URGENT Field Safety Notification

HeartStart Intrepid Monitor/Defibrillator (867172)
Service Manual Electrical Safety Test Issue

10-OCT-2023

A three-pin power socket will be visible on Class I HeartStart Intrepids as shown below:

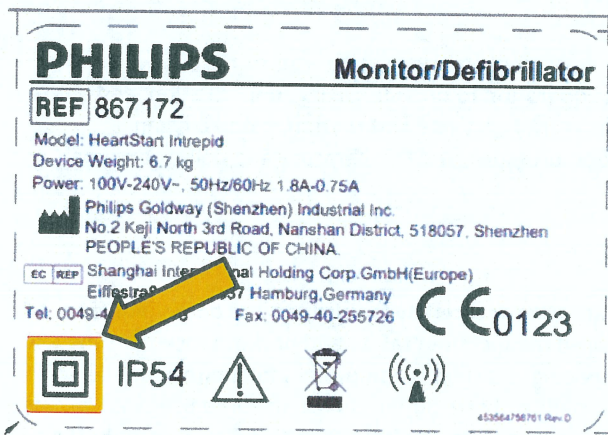
A Class I HeartStart Intrepid power supply can be identified by having a three-pin power socket and via the label on the bottom of the device.
